## ADDENDUM #3

**CCF CTC Tuckpointing Main Building Phase 1**

**DAS#9114.01**

**Dated: June 26, 2020**

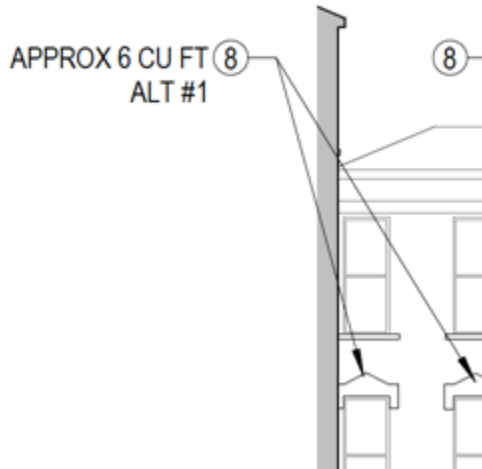
- J. If so is it required that the successful contractor be certified by the state of Iowa? *A> The State of Iowa will employ a certified asbestos abatement contractor for removal of asbestos material.*
- K. On the plans when figuring does this mean 6 CF for each location or combine for the 2 called out. Would this indicate 6 CF or 12 CF?

*A> 6 cubic feet. Clarification for Alternate #1, reference Keyed Exterior Elevation Note #8. The quantity of stone shown (in cubic feet of material) at each instance of the note is intended as the sum of all the individual locations indicated by the arrow heads stemming from the note.*
